# M.M. Knitwear Ltd. (Extension 2)

18 May 2026

2. Observation

**Observation 08:** Non-engineered structure, lack of design documents and no obvious lateral stability system (Yarn Shed).

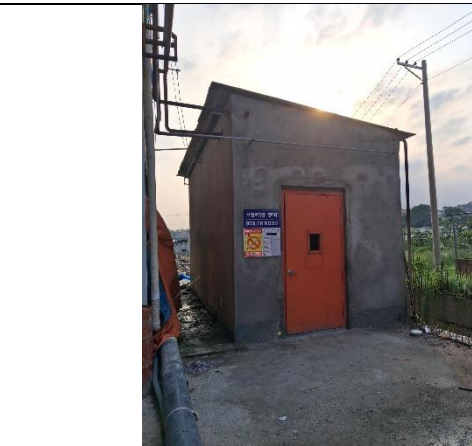
**Description:** During the inspection, no obvious lateral stability systems (bracing and compression struts) were observed. So, the lateral stability system of the structure is incomplete. Also, the shed was framed with bamboo and timber resting over 100 mm X 100 mm RC posts in an non-engineered manner (without any engineered connection). During the inspection, the design report and as-built structural drawings were unavailable on site. The building engineer is required to prepare a set of design documents (considering lateral stability), which shall be prepared in compliance with section 1.9.1, part-6 of BNBC and submit to RSC for review.

| Item No | Observation                                                                                            | Action Plan                                                                                                                                                                                                                   | Timeline       |
|---------|--------------------------------------------------------------------------------------------------------|-------------------------------------------------------------------------------------------------------------------------------------------------------------------------------------------------------------------------------|----------------|
| 8.      | Non-engineered structure, lack of design documents and no obvious lateral stability system (Yarn Shed) | The building engineer is required to prepare a set of design documents (considering lateral stability), which shall be prepared in compliance with section 1.9.1, part-6 of BNBC and submit to RSC for review.                | within 6 weeks |

**Observation-10: Mismatch in the as-built drawing (Security building)**

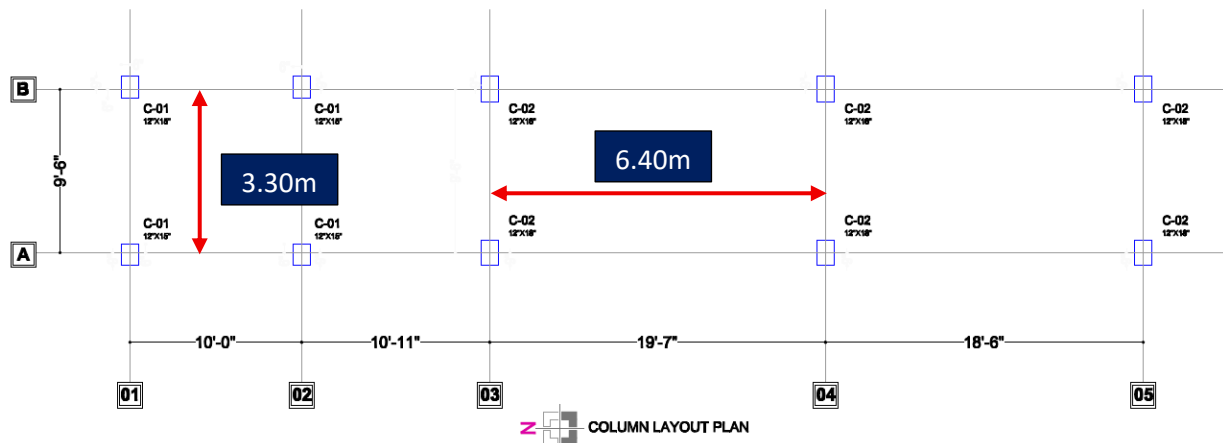
**Description:** Grid dimension at y-direction was found 3.30m instead of 2.9m and at grid-03~grid-04 dimension was found 6.40m instead of 5.96m. Additionally, architectural drawings were not available.

The building engineer is required to survey the structures and prepare comprehensive as-built drawings.
